12/09/20	Deleted Reconstruction Callout R6. Added Reconstruction Callout R5.
DATE	REVISION
STATE OF HAWAII DEPARTMENT OF TRANSPORTATION HIGHWAYS DIVISION	
ROADWAY PLAN	
Vineyard Blvd & Queen Emma St	
ADDITIVE ALTERNATE #1	
Traffic Signal Modernization, Oahu, Phase 1	
Federal-Aid Project No. STP-0300(163)R	
Scale: 1"=10'	Date: Oct. 2020
SHEET No. R-19 OF 81 SHEETS

Traffic Signal Modernization, Oahu, Phase 1

Federal-Aid Project No. STP-0300(163)R

TERMINAL IMPACT ATTENUATOR

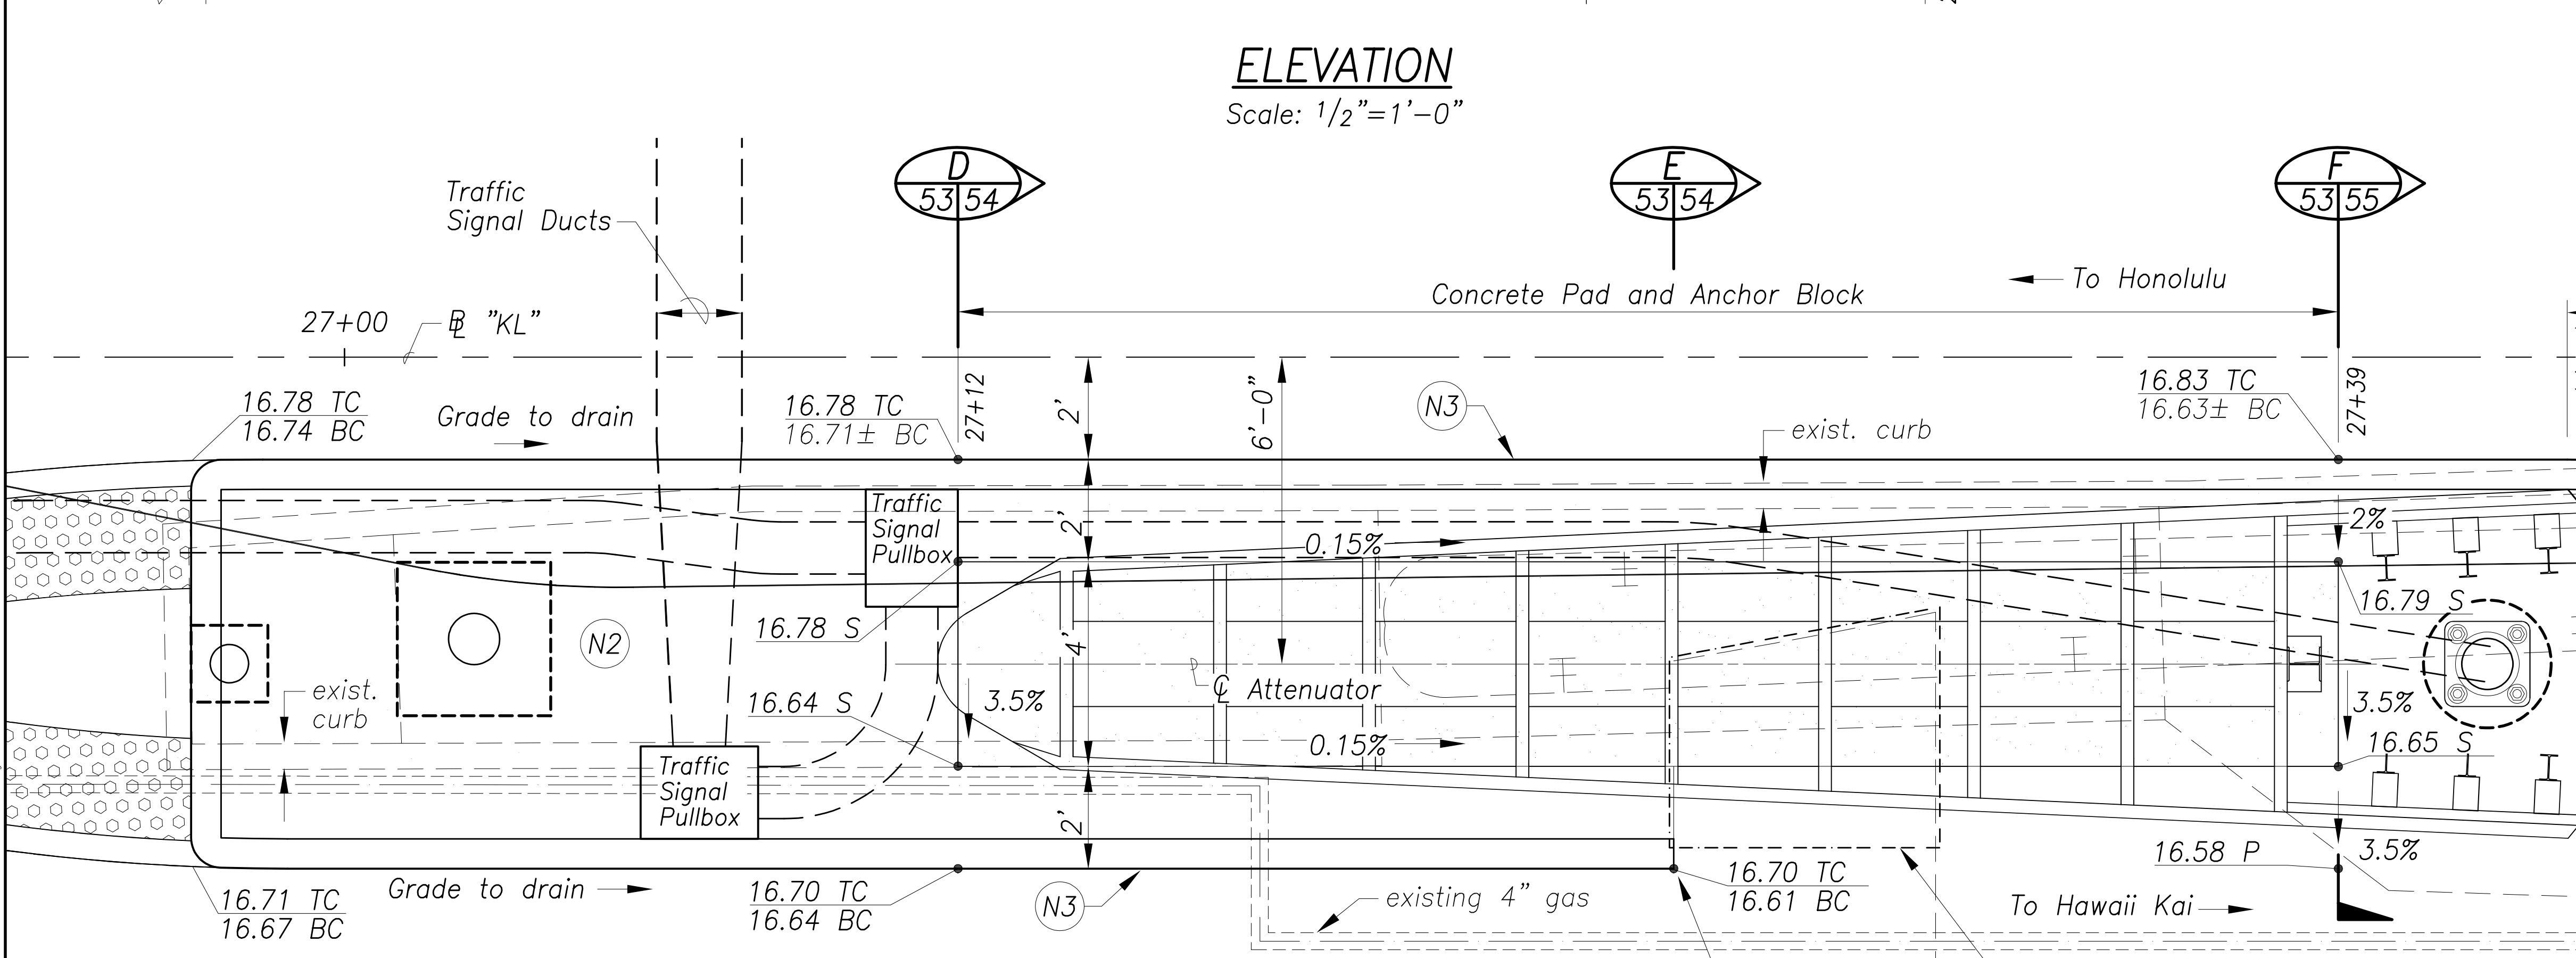
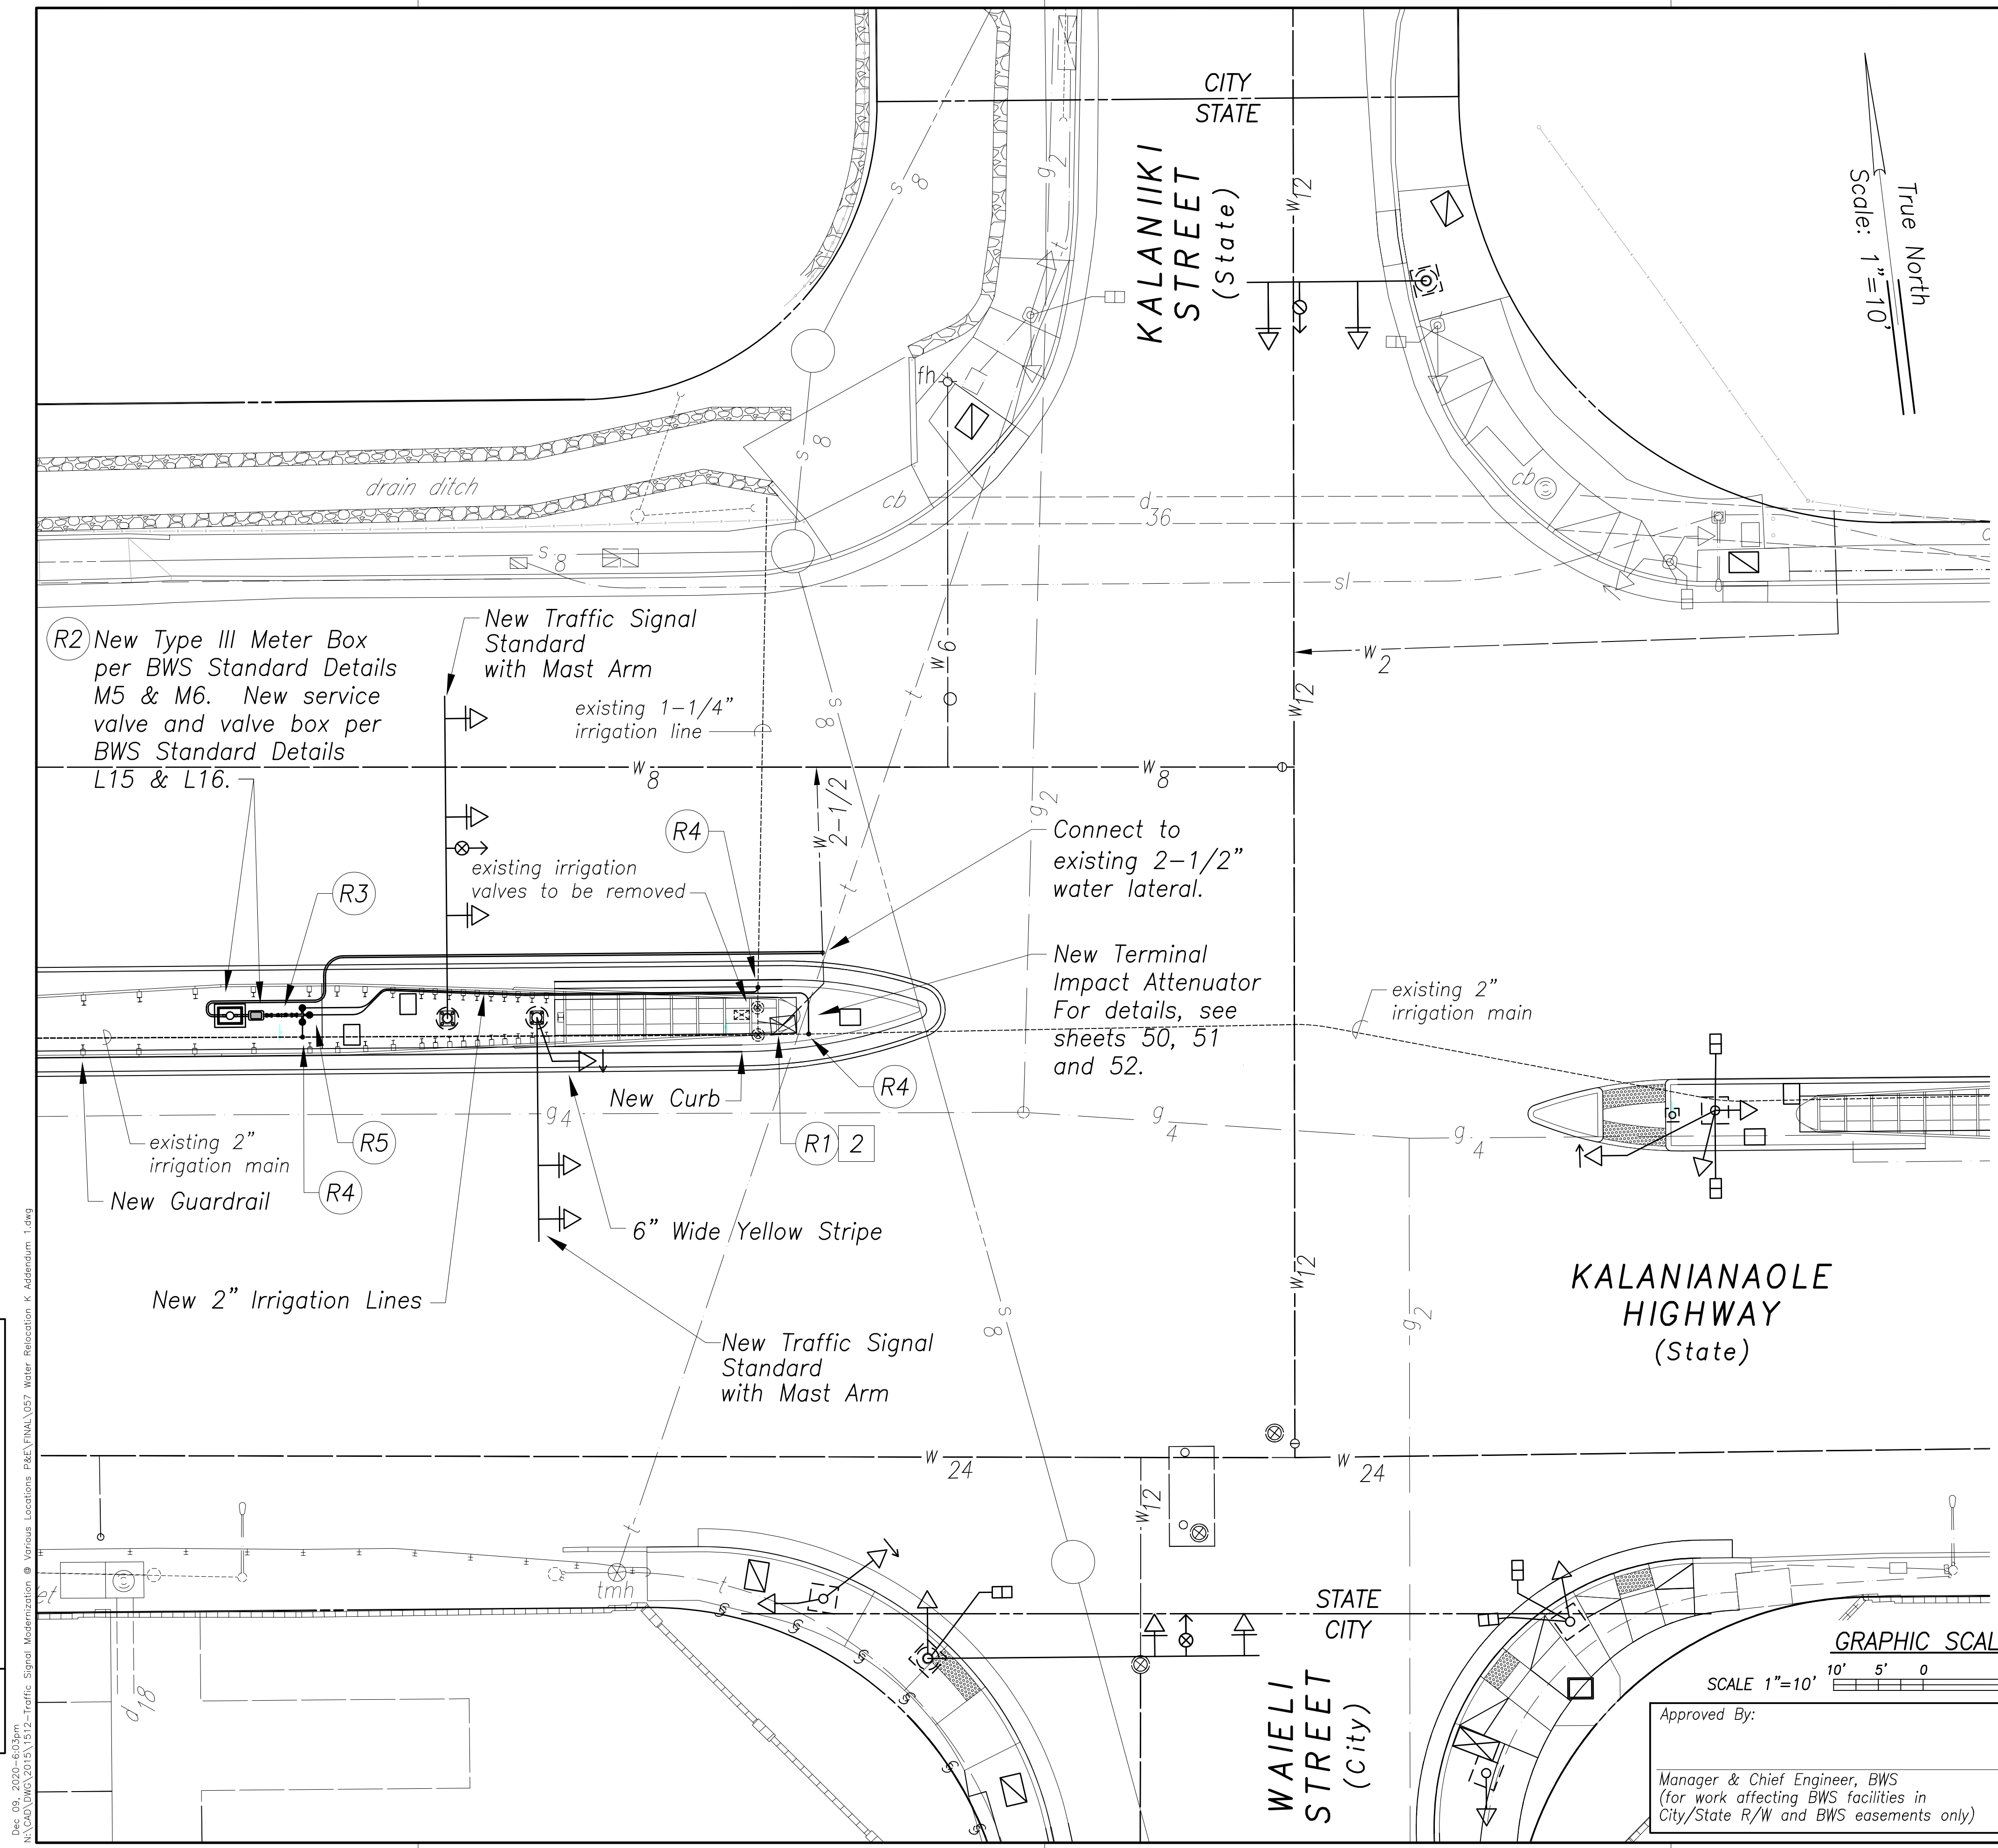
12/09/20	Added new construction callout N8. Revised Elevation view and added N8.
DATE	REVISION

- (N2) Concrete Sidewalk per Standard Plan D-15.
- (N3) Curb, Type 2A Modified. For details, see sheet 51.
- (N8) Terminal Impact Attenuator – HDOT Approved MASH Compliant, TL-3; and Transition Section. The Transition section shall be incidental to the Terminal Impact Attenuator and will not be paid for separately.
- (N14) Hot Mix Asphalt (HMA) Sidewalk
 - 2-inch thick, HMA Pavement State Mix No. V
 - 6-inch thick, Aggregate Base Course
 - 6-inch thick, Scarify and re-compact to 95% relative compaction

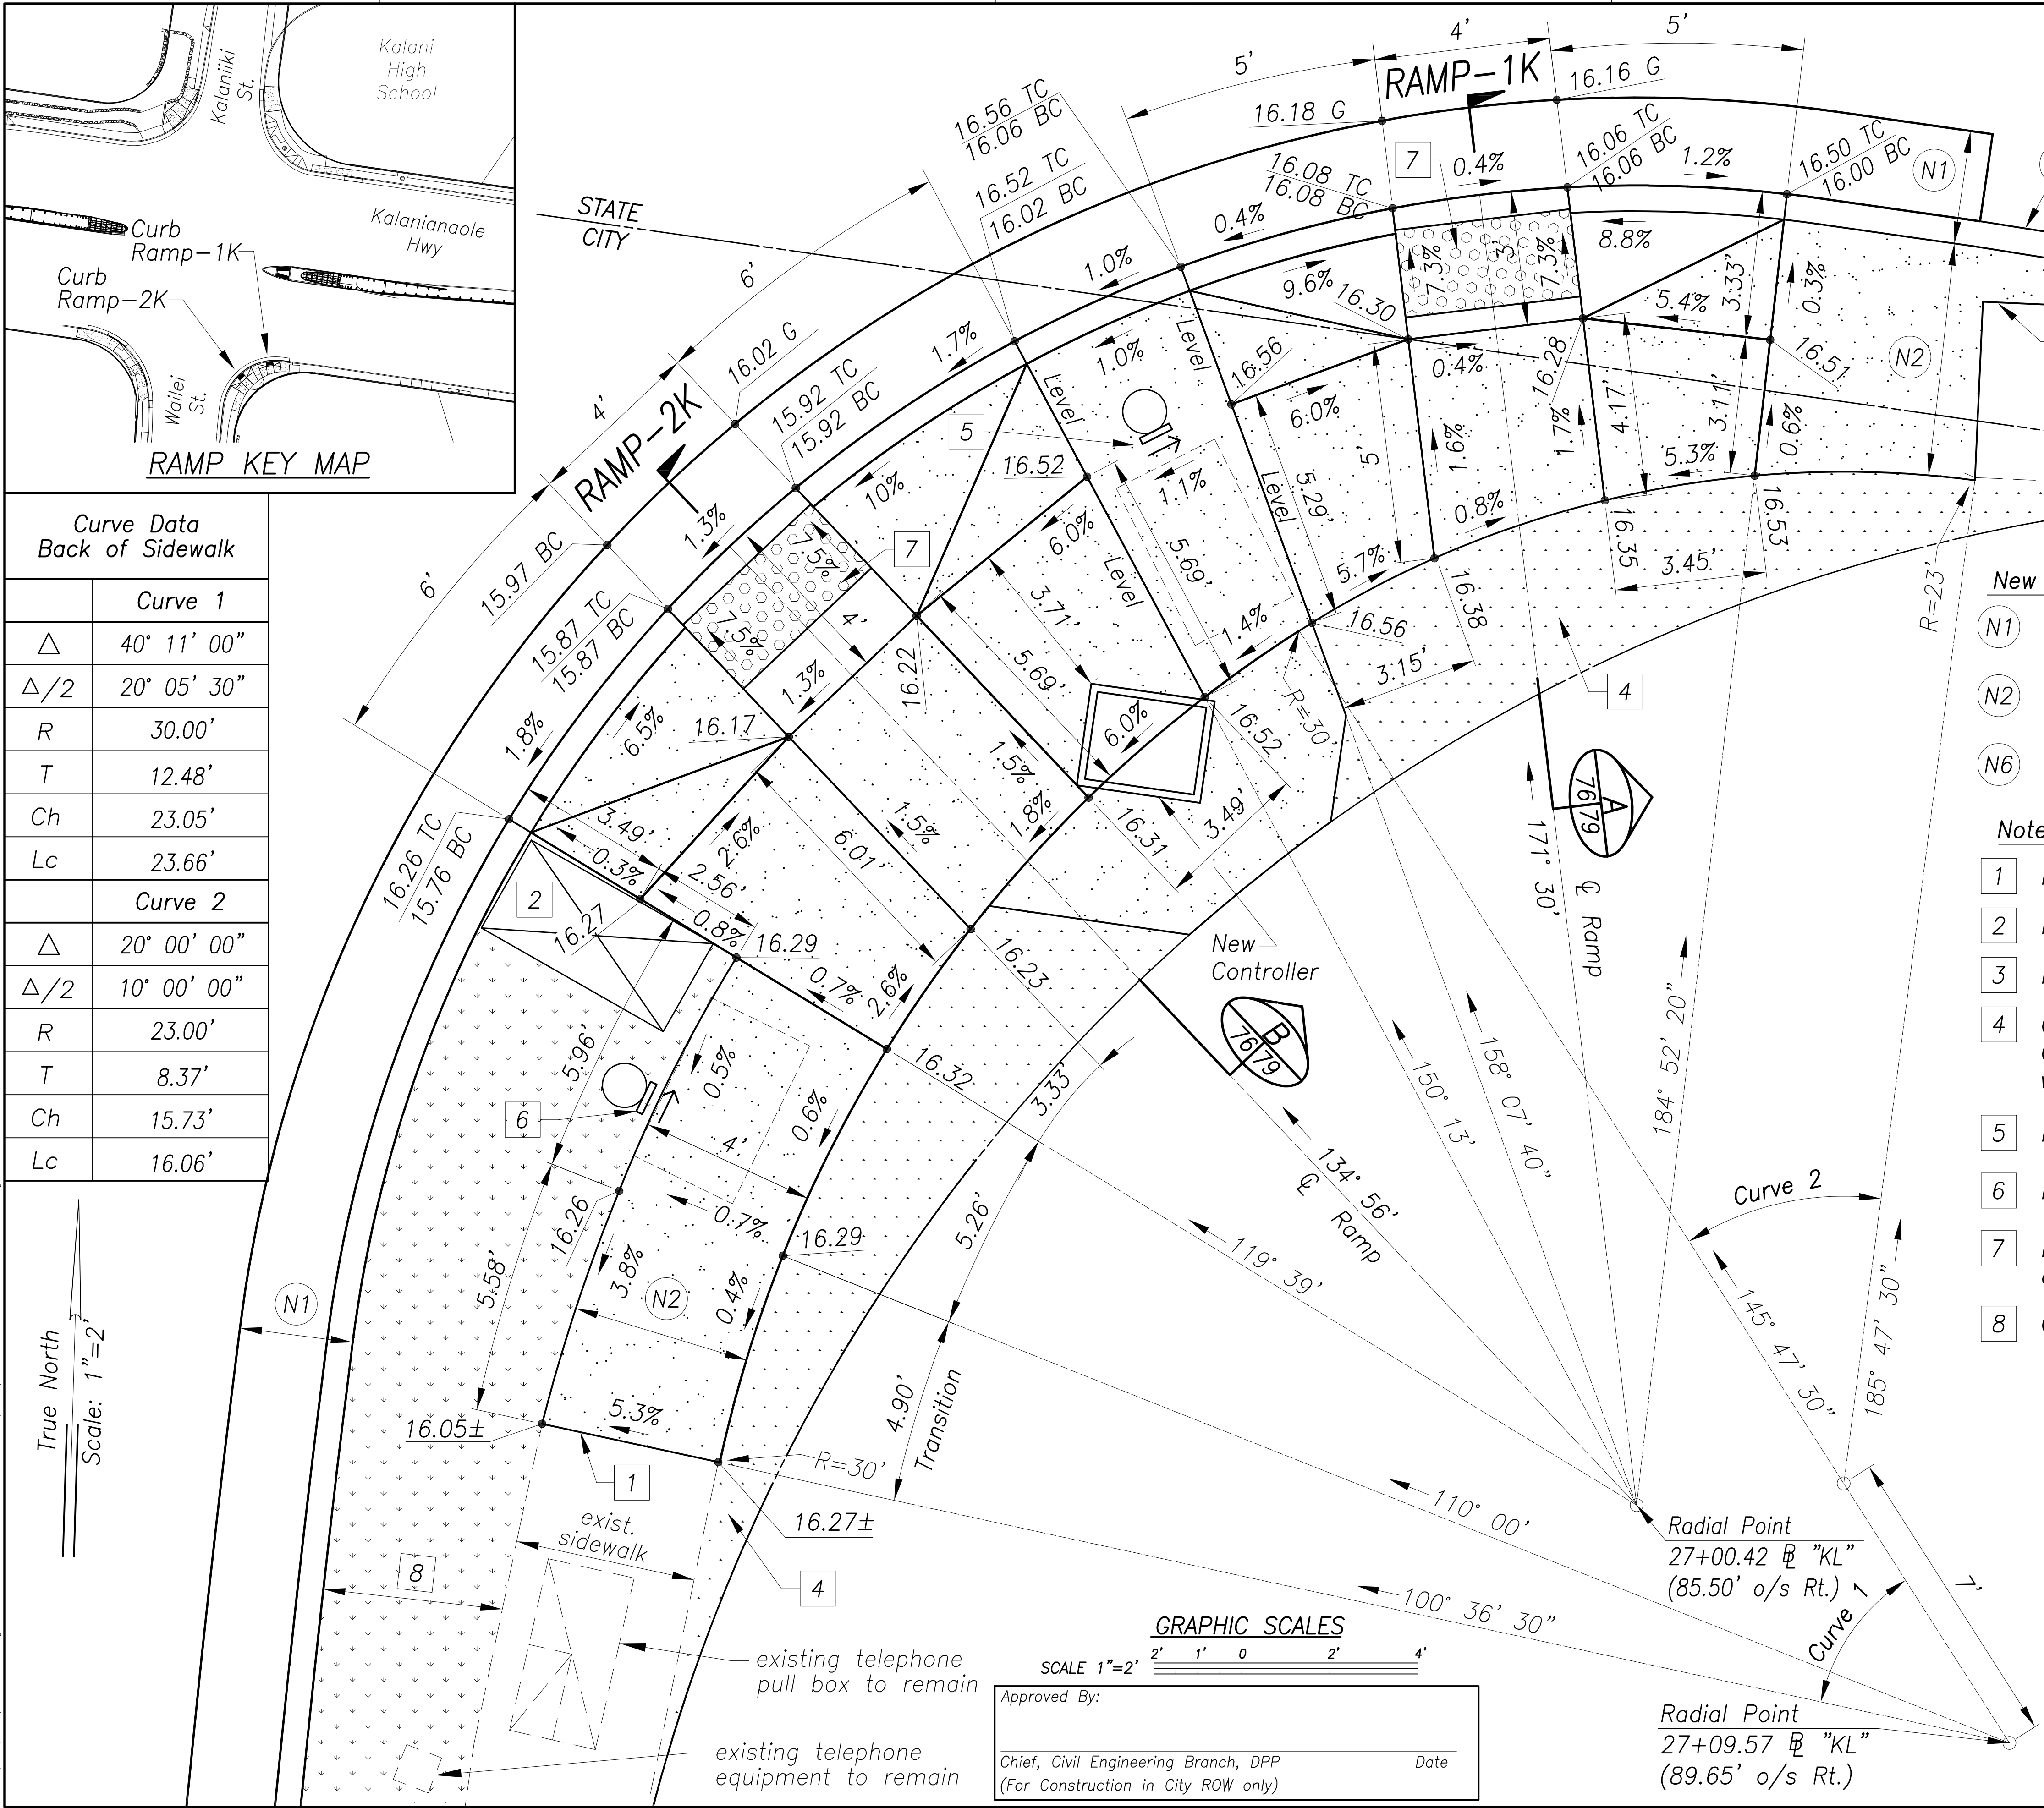
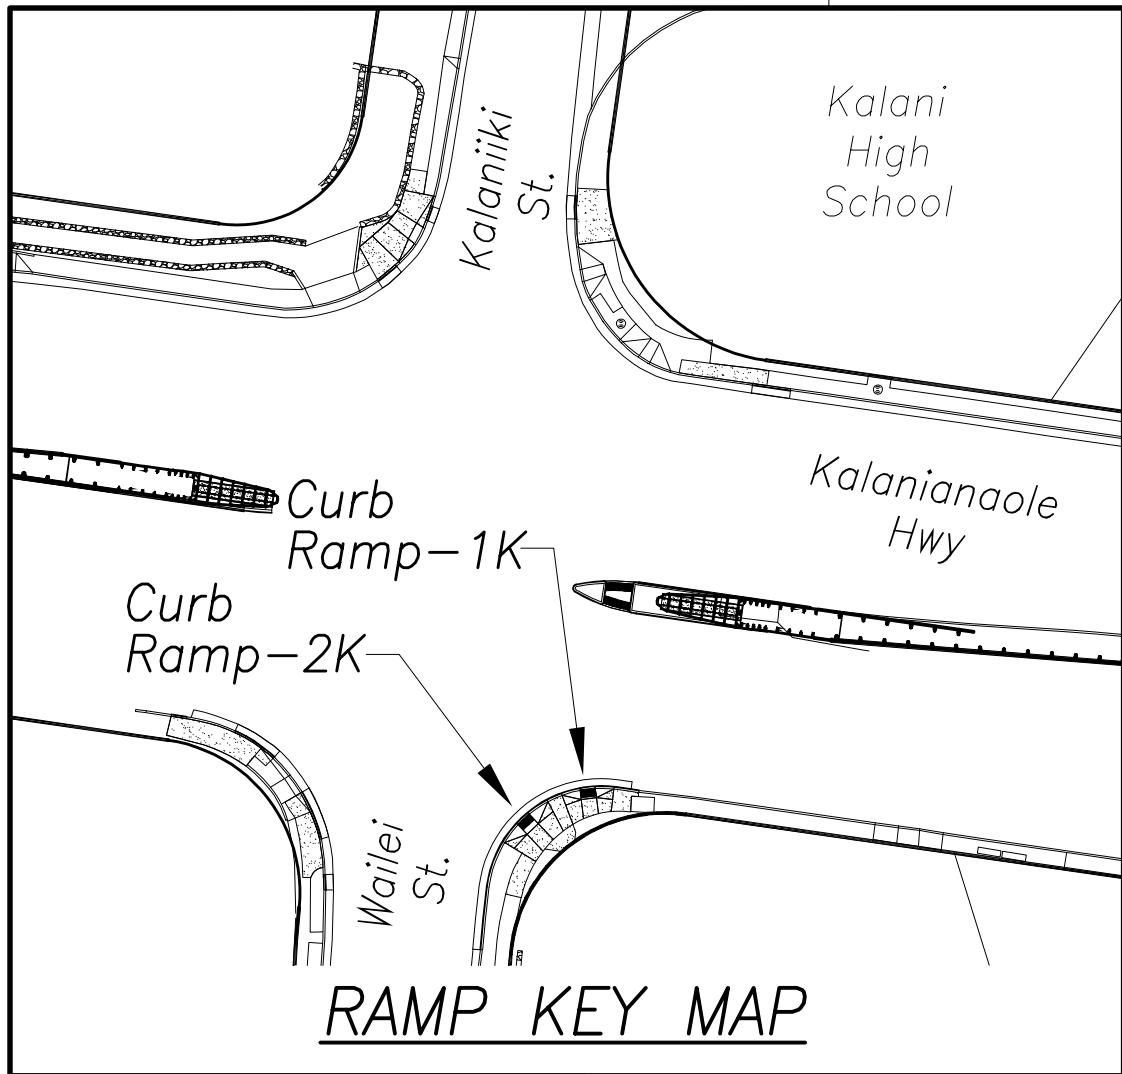
12/09/20	Revised Note 4.
DATE	REVISION
STATE OF HAWAII DEPARTMENT OF TRANSPORTATION HIGHWAYS DIVISION CURB RAMP PLAN Kalanianaʻole Hwy & Kalaniiki St ADDITIVE ALTERNATE #2 Traffic Signal Modernization, Oahu, Phase 1 Federal-Aid Project No. STP-0300(163)R Scale: 1"=2' Date: Oct. 2020 SHEET No. R-55 OF 81 SHEETS

- 2 Install new traffic signal pull box flush with finish grade.
 - 3 Match into HECO pull box. Provide smooth riding connection.
 - 4 Grassed Surface and 4-inch thick Imported Planting Soil. The Contractor shall restore existing irrigation system affected by his work to equal or better condition; and protect trees to remain.
